Registry No. H12063

General Locality Chatham Strait

Sublocality Southern Tebenkof Bay

Revisions and Corrections Compiled During Office Processing and Certification

Figure 2: Crossline and main scheme differences (gray indicates agreement, cool colors indicate crosslines shoaler than main scheme and warm colors indicate crosslines are deeper).

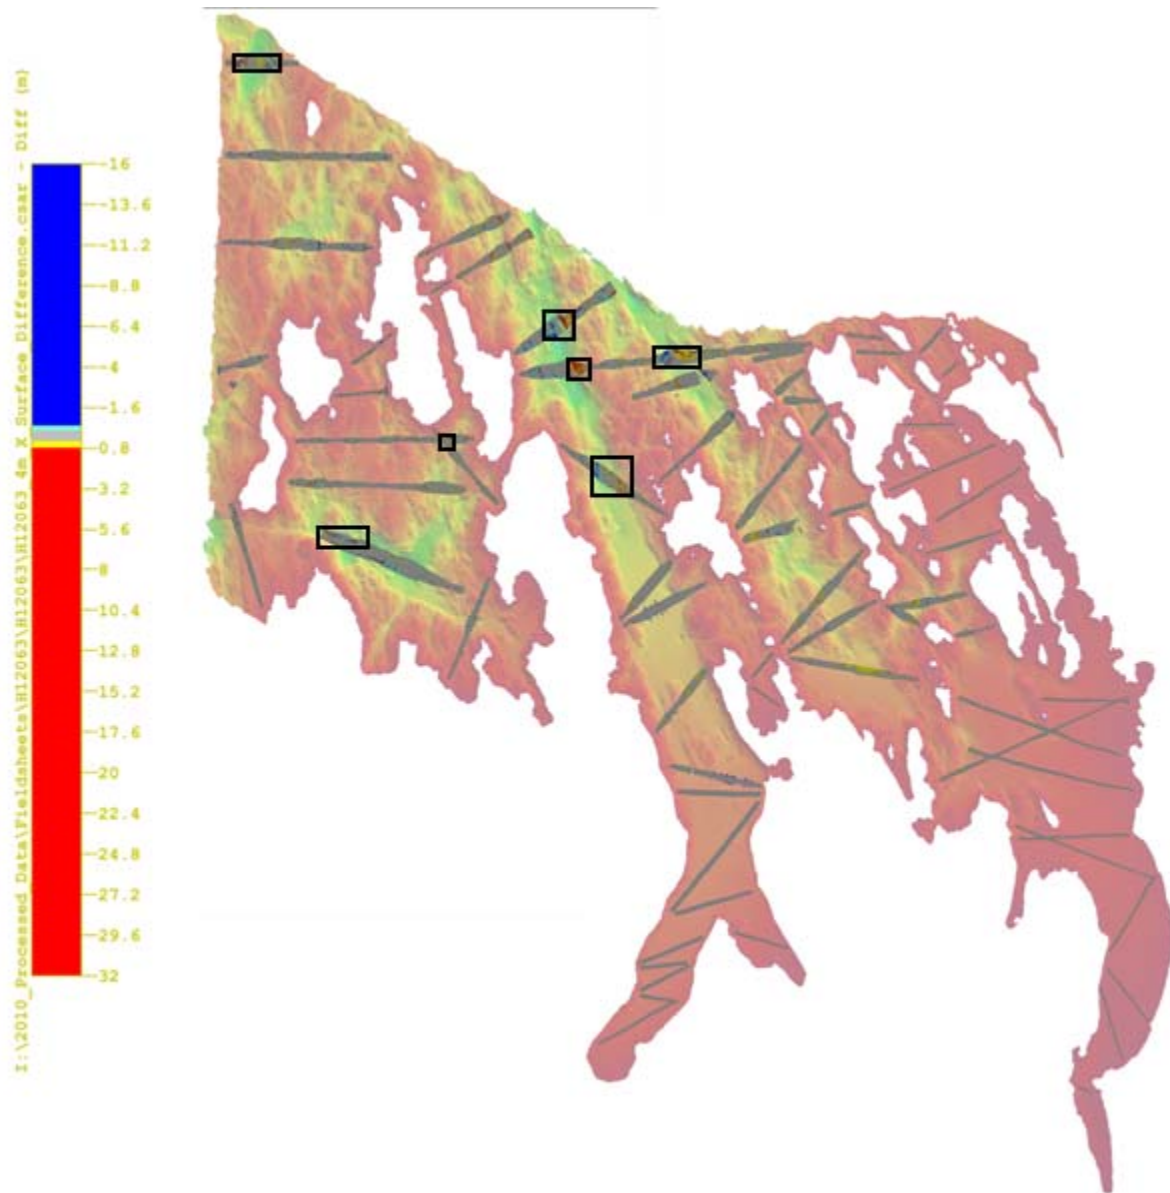
The areas with the greatest disagreement between crosslines and main scheme lines are areas where the seafloor is very dynamic.⁴ Areas in the survey where this is most prevalent are outlined in black in Figure 2.

⁴ Concur with clarification. Greater differences are to be expected in areas of dynamic topography. The crossline comparison showed good agreement otherwise.

Figure 4: Reson 8125 roll artifact found predominantly in the 1-meter finalized surface near Windfall Island. Vertical exaggeration is 5.

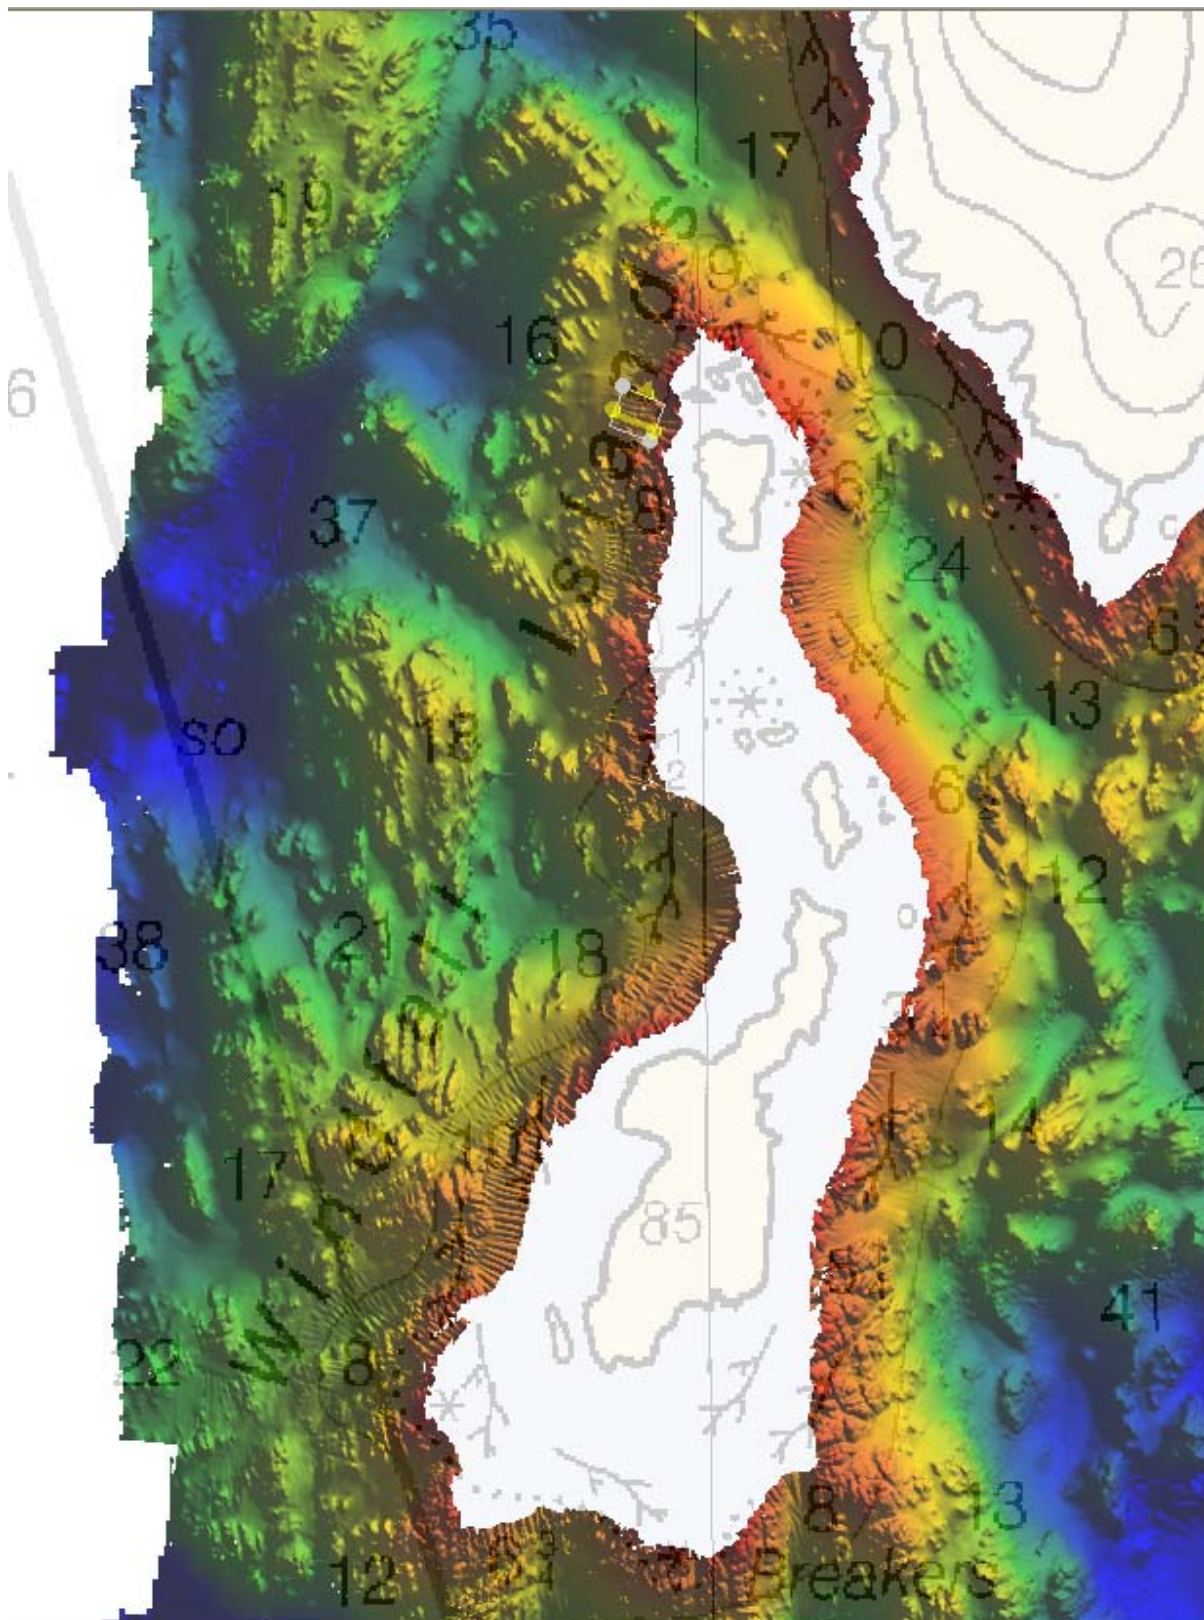
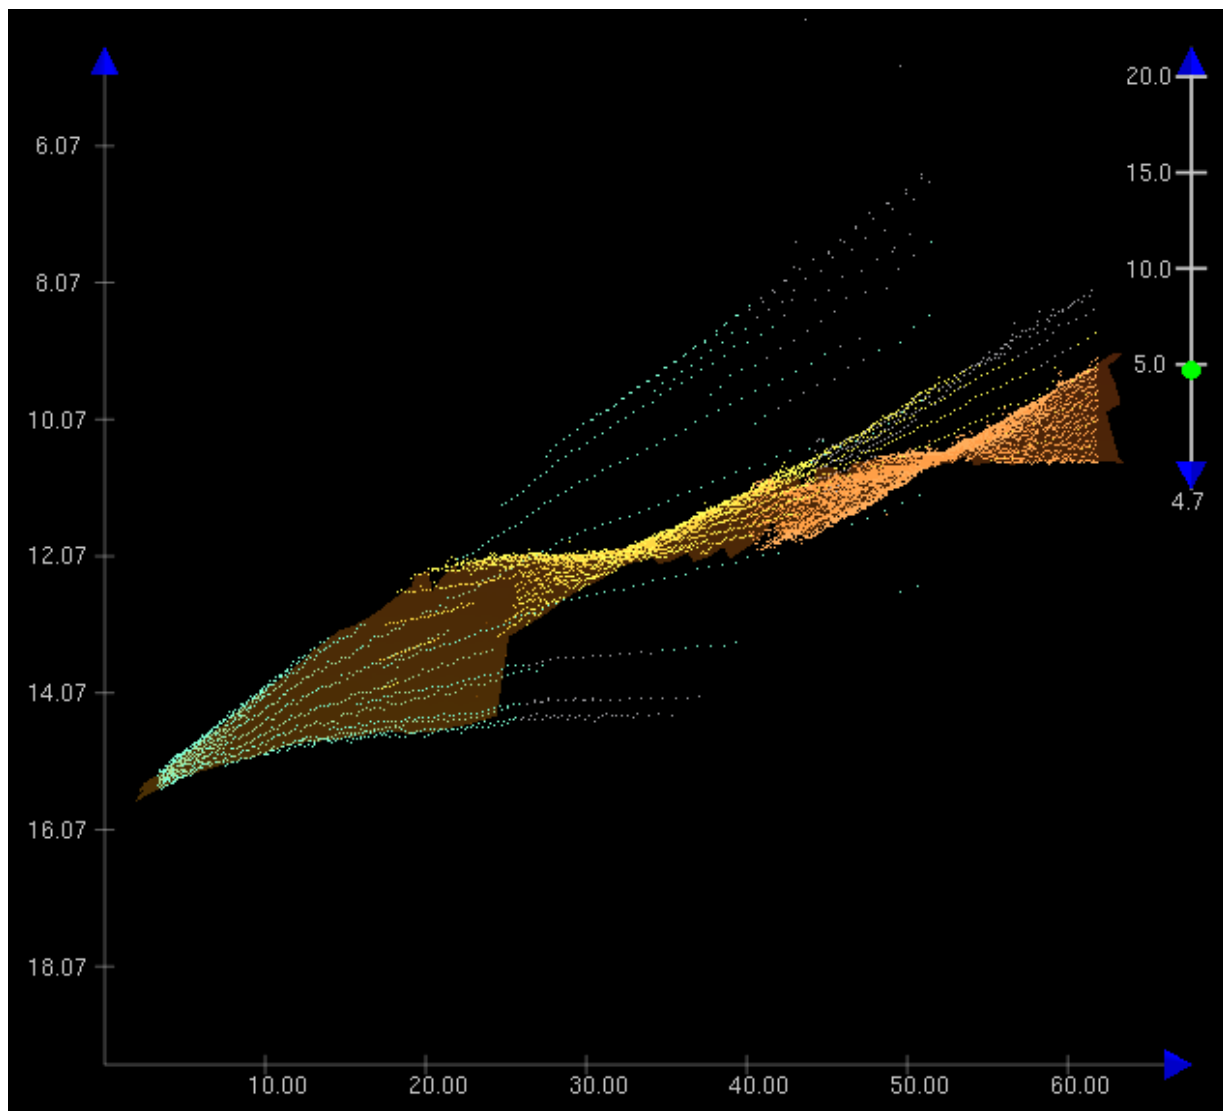
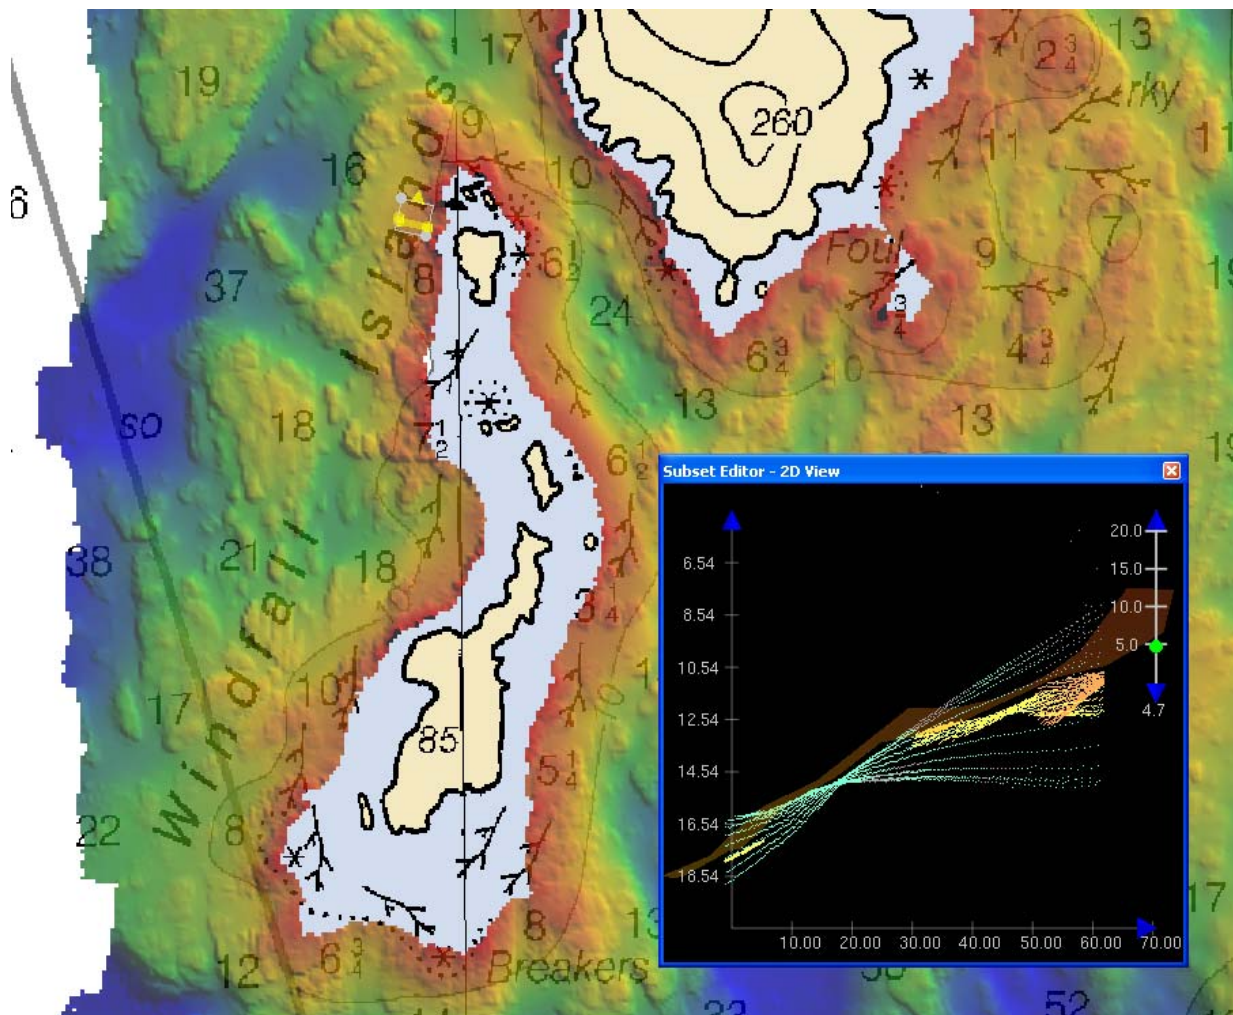
A roll artifact is apparent in some Reson 8125 data, located predominantly in surfaces to the west and northwest of the Windfall Islands as well as to the east side of Explorer Basin and south of Step Island. The artifact is thought to be due to disabled roll stabilization in the Reson 8125 processor set-up. The areas were manually cleaned in CARIS Subset Editor to remove all spurious soundings. The finalized surfaces follow the soundings more closely (Figure 4 and 5) as opposed to the 8-meter combined surface (Figure 6) that trends toward the shoaler soundings.⁷

⁷ Concur with clarification. A good portion of the tilted 8125 data did not meet specifications. During the Survey Acceptance Review, 56 lines of tilted 8125 data were rejected. The remaining data meets specifications.

Figure 7: Example of vertical tide offset found northwest of Petrof Bay. Crossline in CARIS Subset Editor box was acquired by Launch 2806 on DN 310 and main scheme lines were acquired by Launch 2807 on DN 278. Vertical exaggeration is 5.

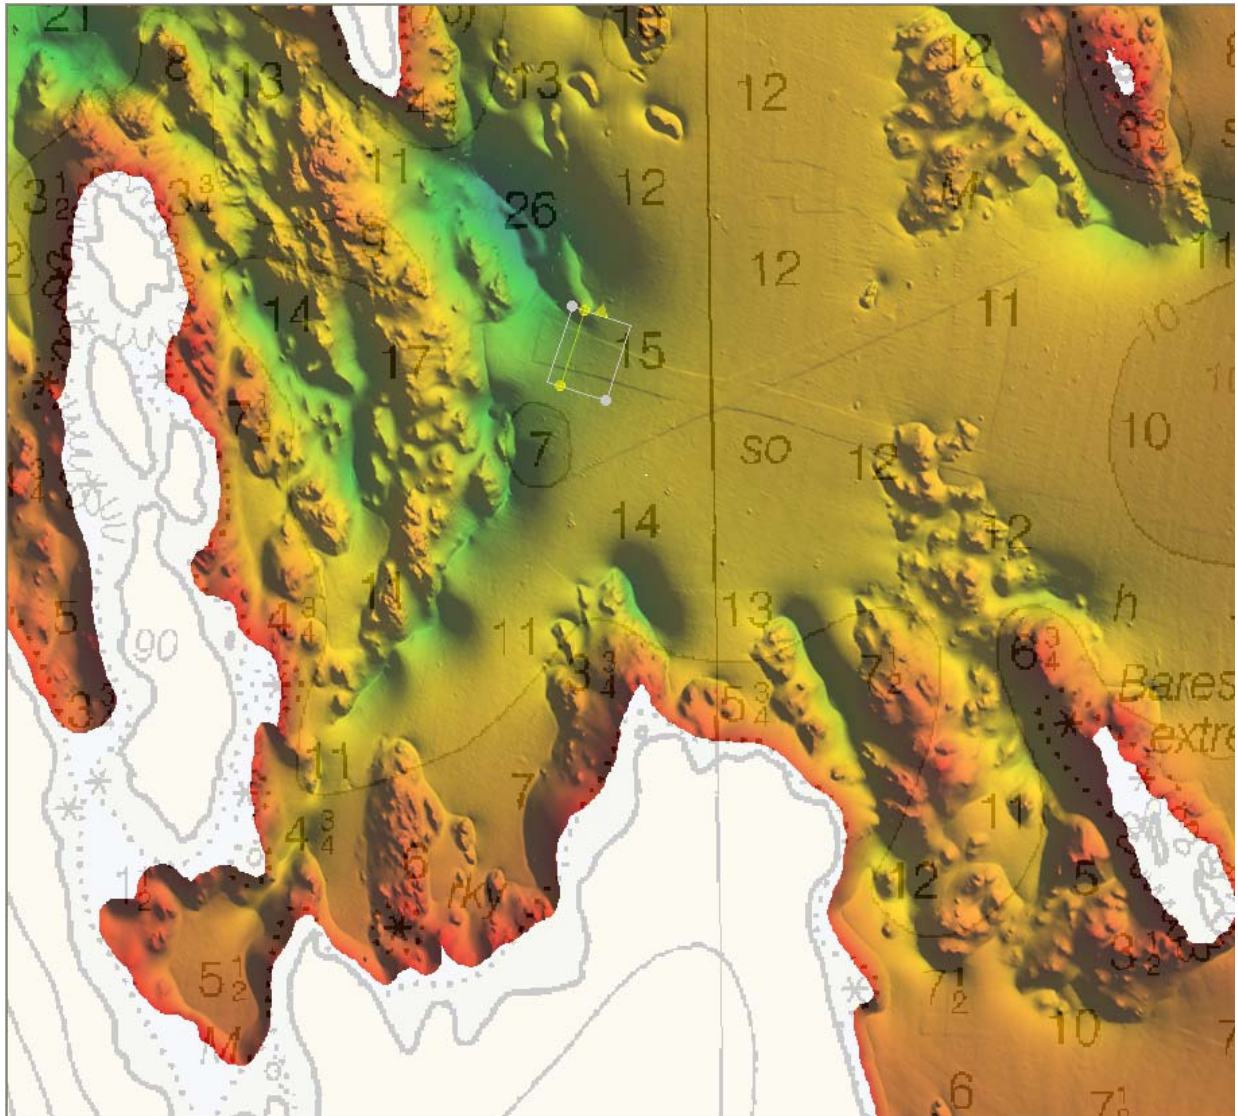
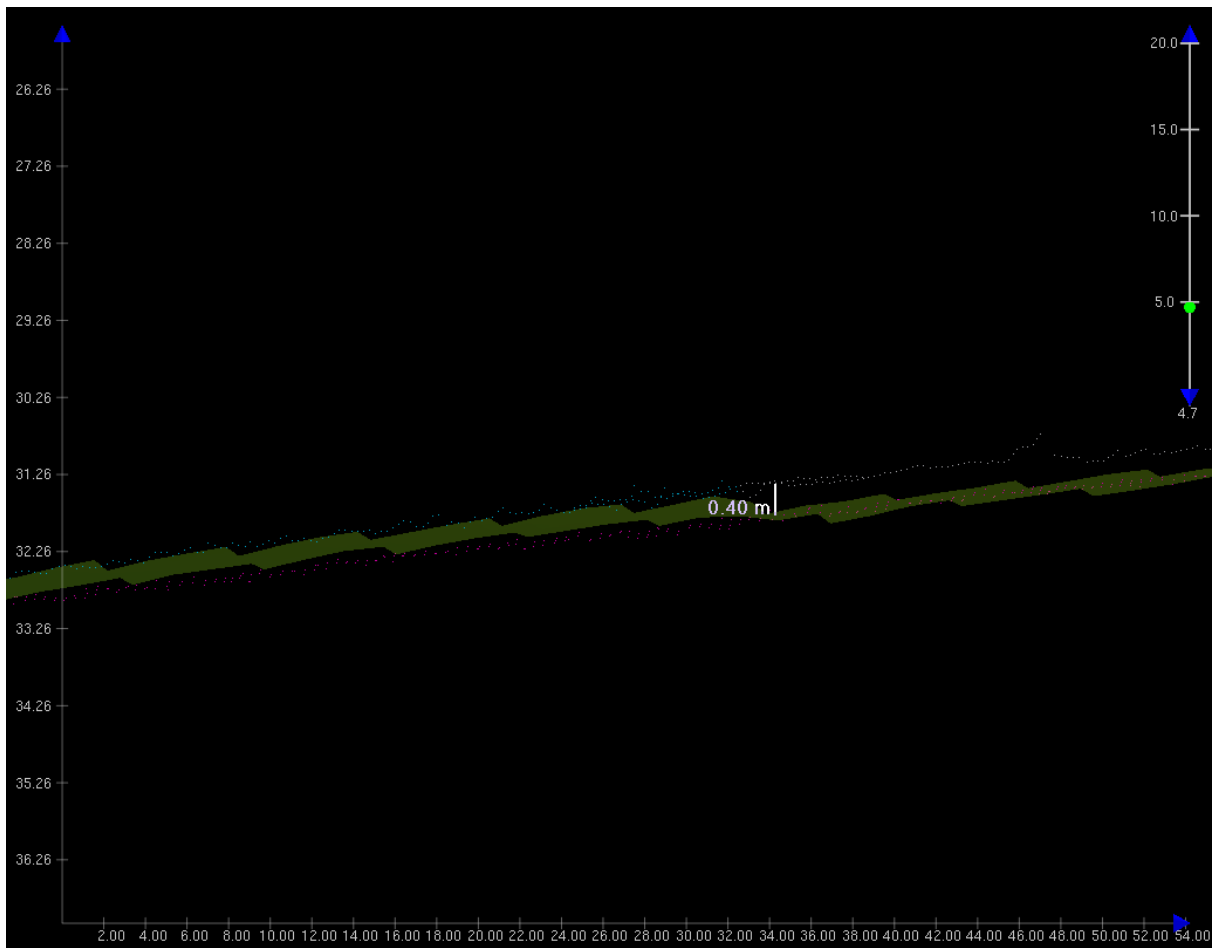
Vertical tide offsets ranging from 10 to 40 centimeters are found between main scheme data and crosslines from Launch 2806 on DN 310 in the eastern half of H12063 but the disagreement is within the total allowable vertical uncertainty of the depth range.⁹

⁹ Concur with clarification. The data is adequate for charting.
